CONVAIR

COMMERCIAL CHANGE PROPOSAL

CUSTOMER: Alaska Airlines Inc.

MODEL 22-21(#2) (Convair "880")

Page 3a
Report No. ZD-22-323
Model 22M

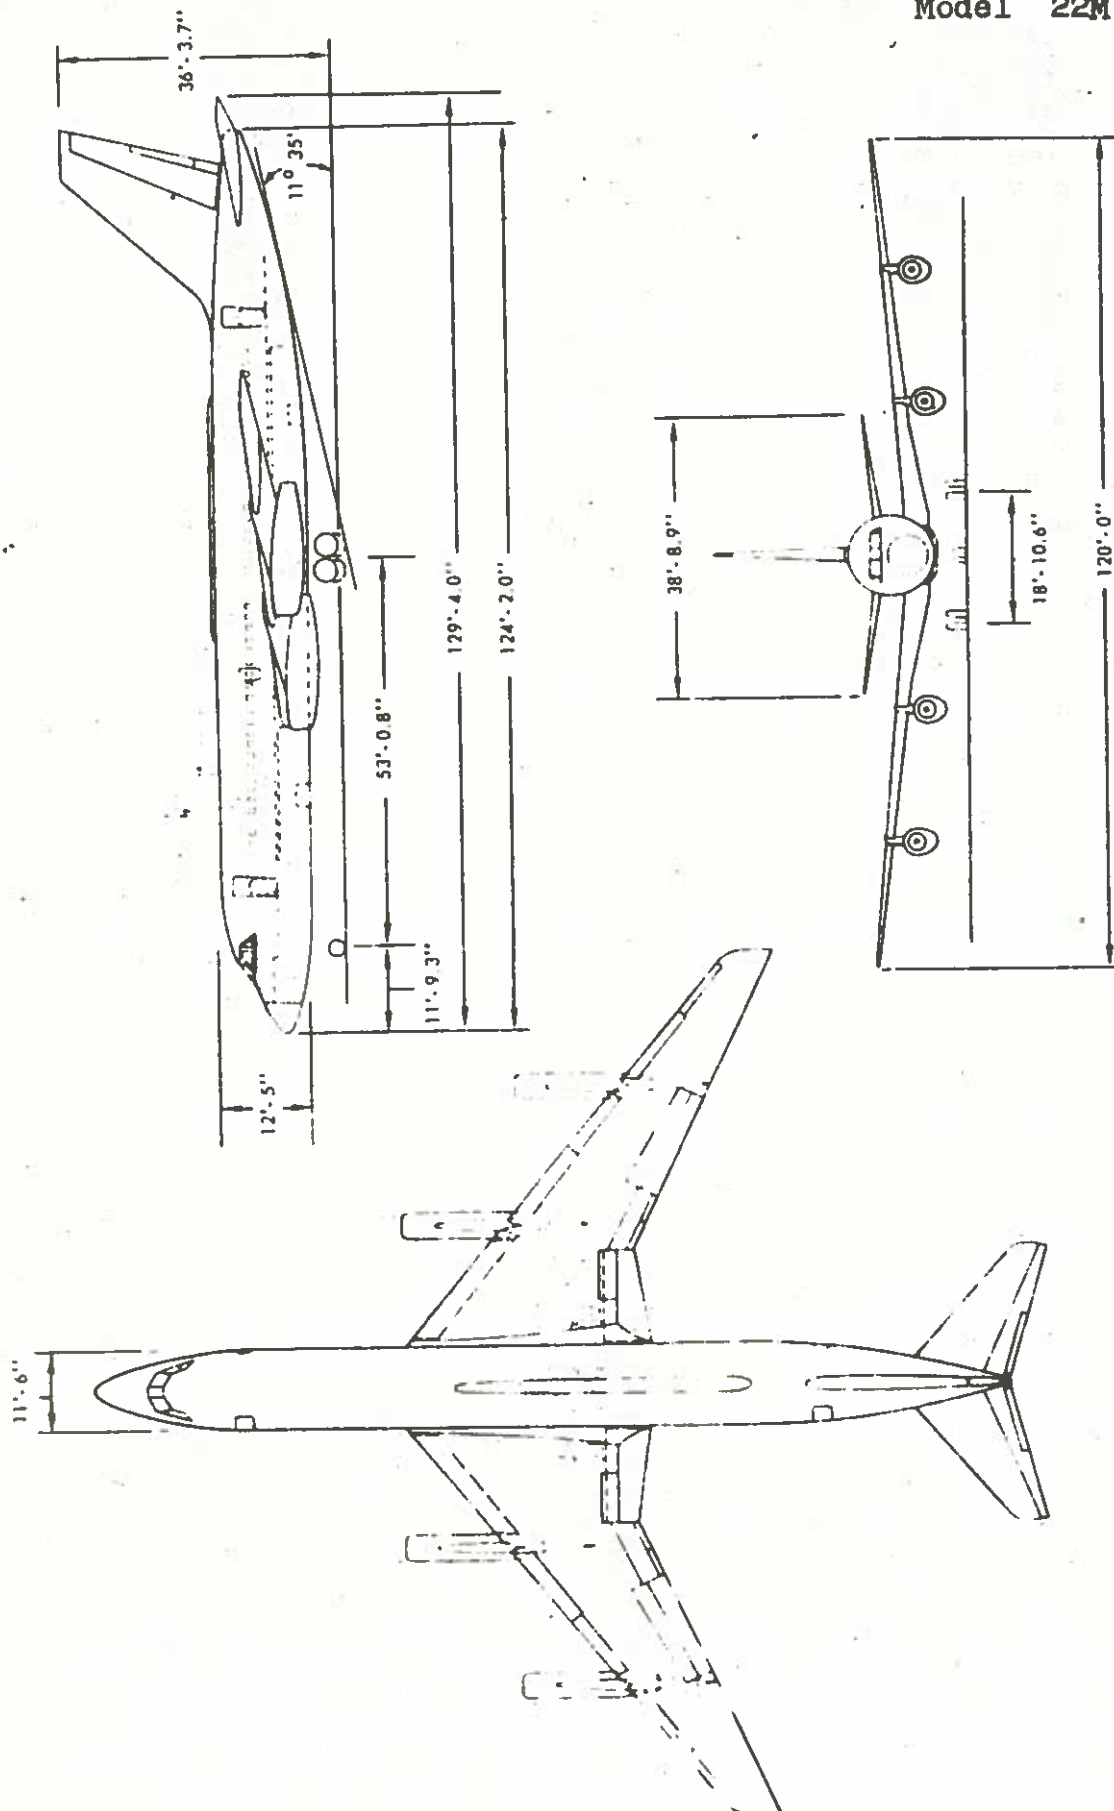
Replace above illustration in the specification with Enclosure (A) which shows Krueger Flap installation between inboard pylon and fuselage, and trailing edge inboard flap extension.

Enclosure: (A) One copy Page 3a - GENERAL ARRANGEMENT (Revised)

Enclosure: (A) One copy Page 94a - GASEOUS OXYGEN SYSTEM (Revised)

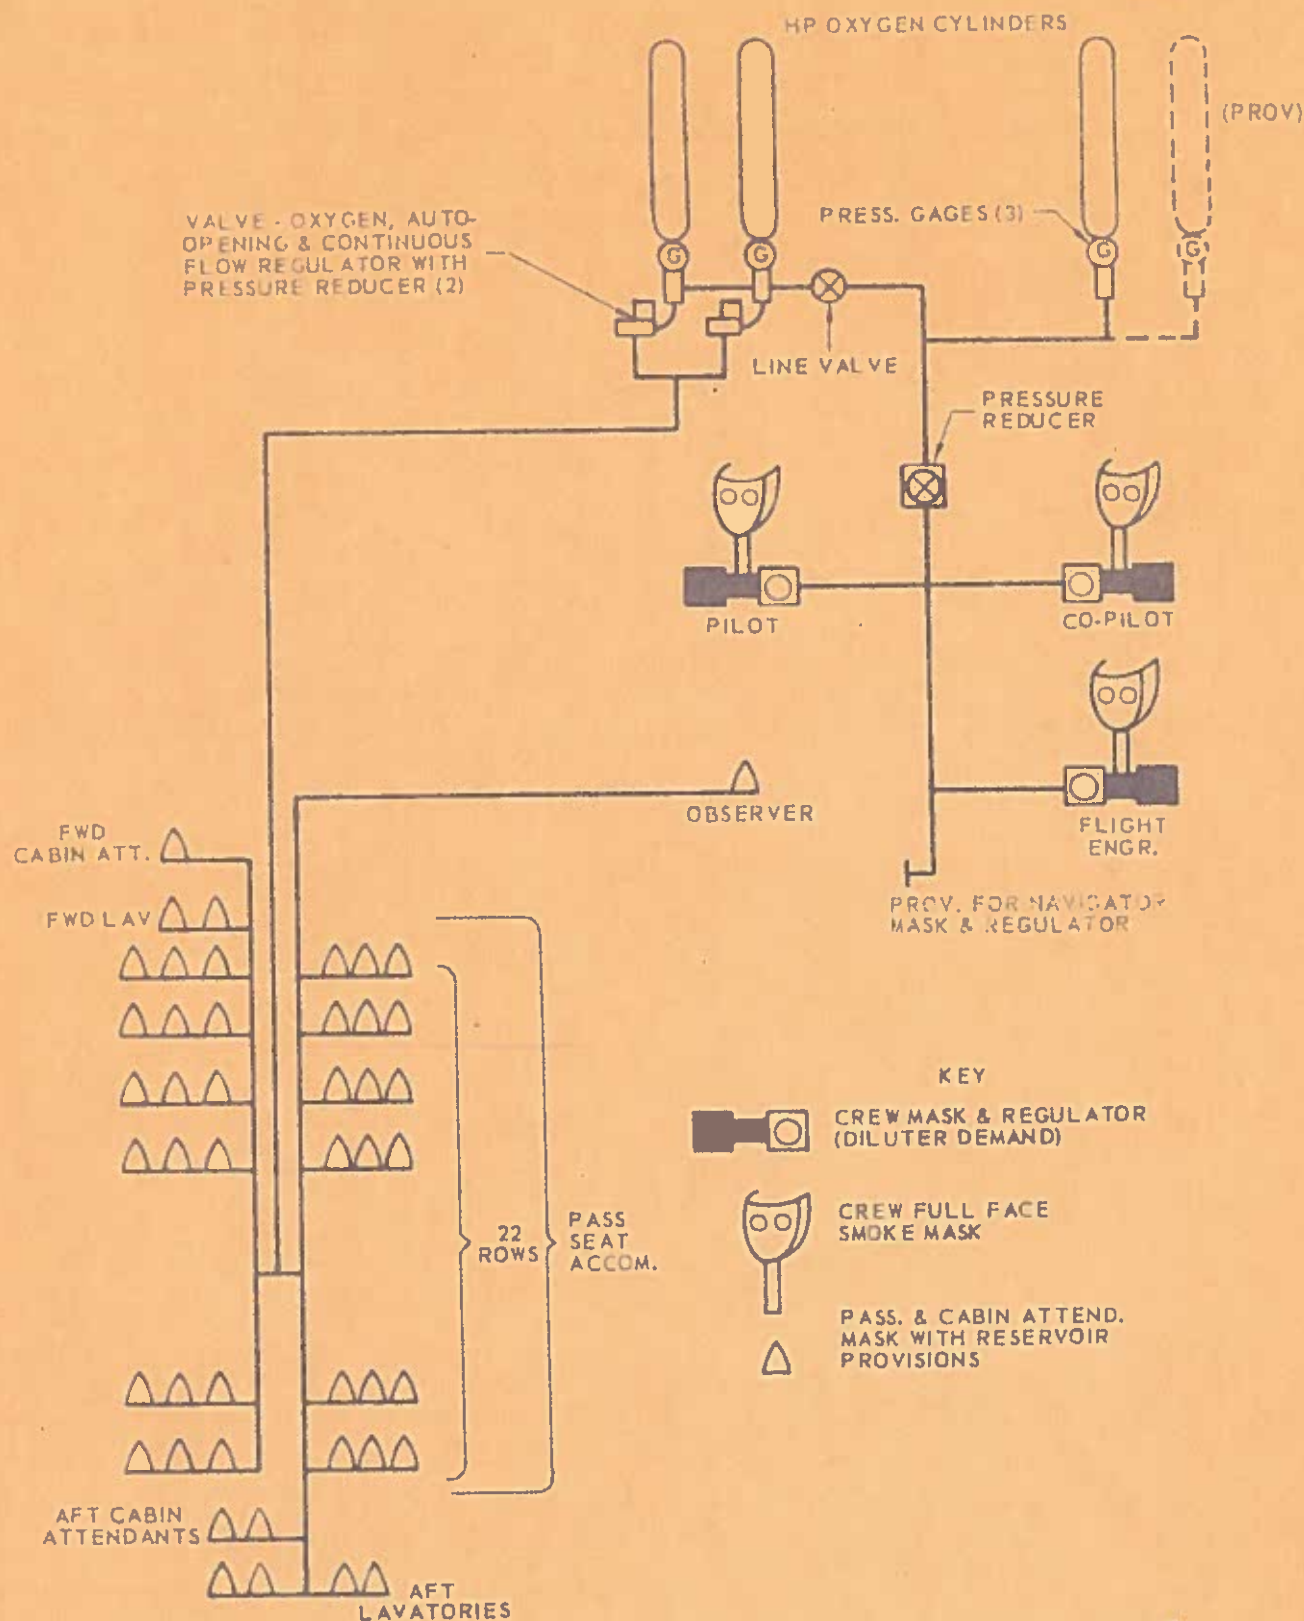
Replace above illustration in the specification with Enclosure (A) which shows provisions for a navigator mask and regulator.

Page 43a, PILOT'S AND COPILOT'S INSTRUMENT PANELS:

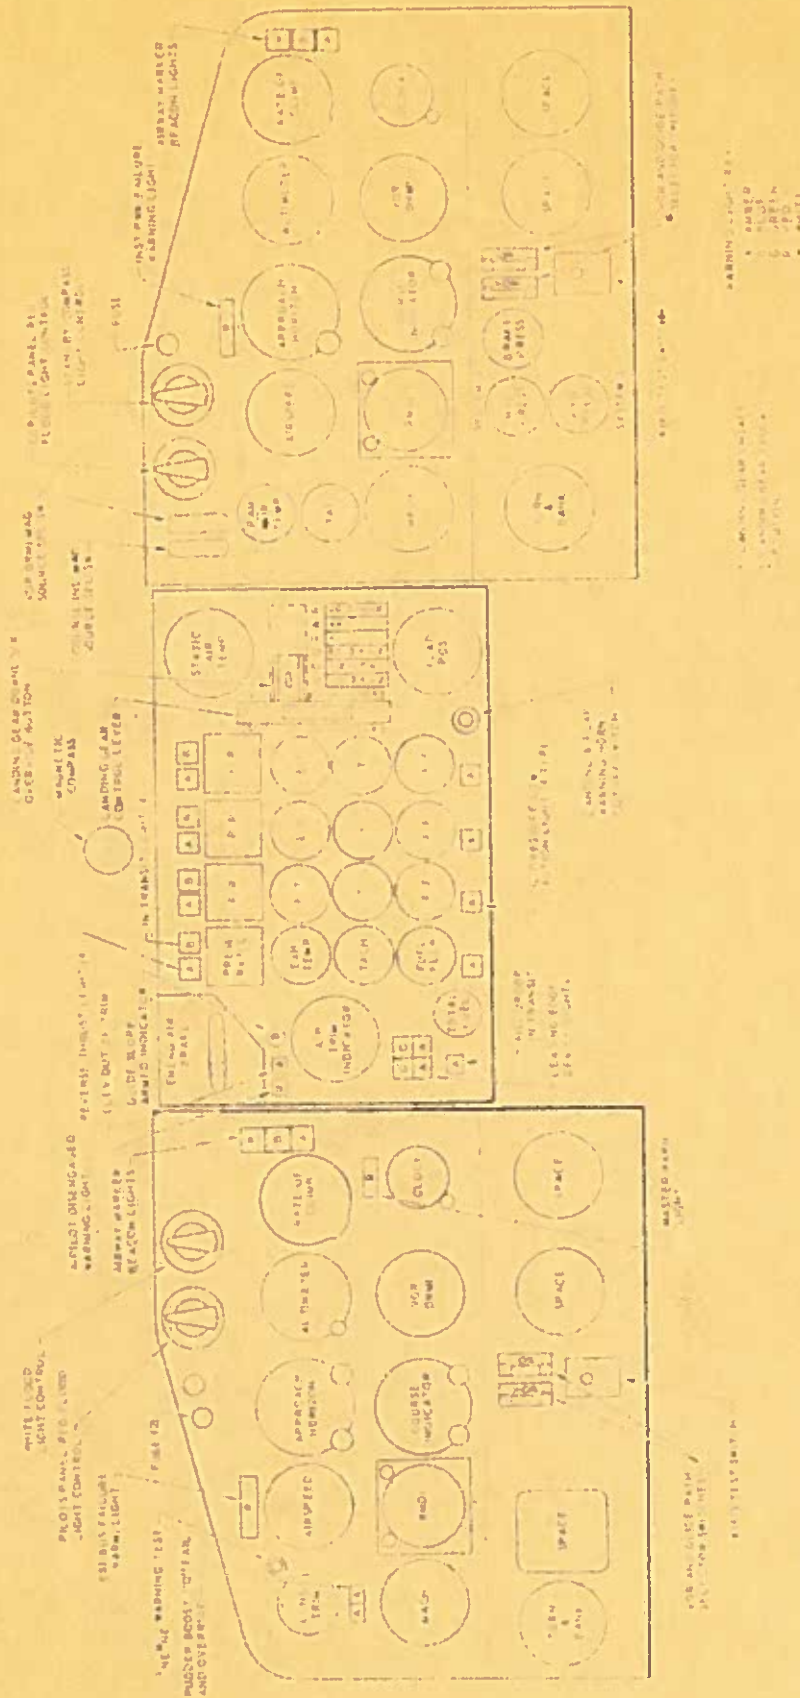
Replace above illustration in specification with Enclosure (A)
which was revised to be in agreement with actual instrument
installation.

Enclosure: (A) One copy Page 43a - PILOT'S AND COPILOT'S INSTRU-
MENT PANELS (Revised)
